Access Compliance Report Public Rights-of-Way (Curb Ramps)

Main Street: MONTECITO_RD Cross Street: MAINWAY_DR Location: SW

ADA ID: RPRK211208122118 Ramp Type: Type 4 - Parallel Initial Pass/Fail: Fail Overall Compliance: No Severity Score: 45

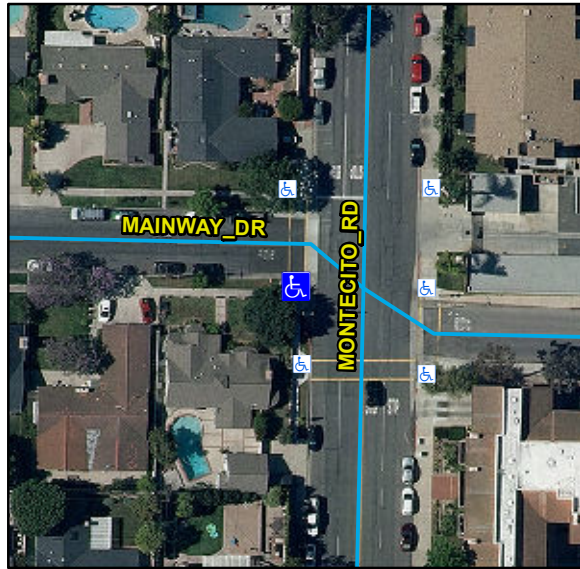
Compliance	Description	Data	Compliance	Description	Data
N/A	Ramp Length LT (in)	117	N/A	Ramp Length RT (in)	113
Yes	Ramp Width LT (in)	111	Yes	Ramp Width RT (in)	111
Yes	Ramp Run Slope LT (%)	1	No	Ramp Run Slope RT (%)	9.5
No	Ramp Cross Slope LT (%)	2.8	No	Ramp Cross Slope RT (%)	7.3
N/A	Landing Present	N/A	N/A	DWS Provided	N/A
N/A	Landing Length (in)	N/A	N/A	DWS Contrast	N/A
N/A	Landing Width (in)	N/A	N/A	DWS Length (in)	N/A
N/A	Landing Run Slope (%)	N/A	N/A	DWS Full Width	N/A
N/A	Landing Cross Slope (%)	N/A		DWS Offset Type	N/A
N/A	Landing Movement Obstructed?	N/A	N/A	DWS Offset Left (in)	N/A
	Landing Movement Type	N/A	N/A	DWS Offset Right (in)	N/A
N/A	Landing Shared	N/A			
N/A	Clear Space	Yes			
N/A	Clear Space To Crosswalk (in)	N/A			
N/A	Marked Crosswalk 1	No	N/A	Marked Crosswalk 2	Yes
	Crossing 1 Direction	E		Crossing 2 Direction	N
	Marked Crosswalk 1 Width (in)	N/A		Marked Crosswalk 2 Width (in)	144

Remove & Replace Curb Ramp With Two New Directional Ramps or Equivalent.
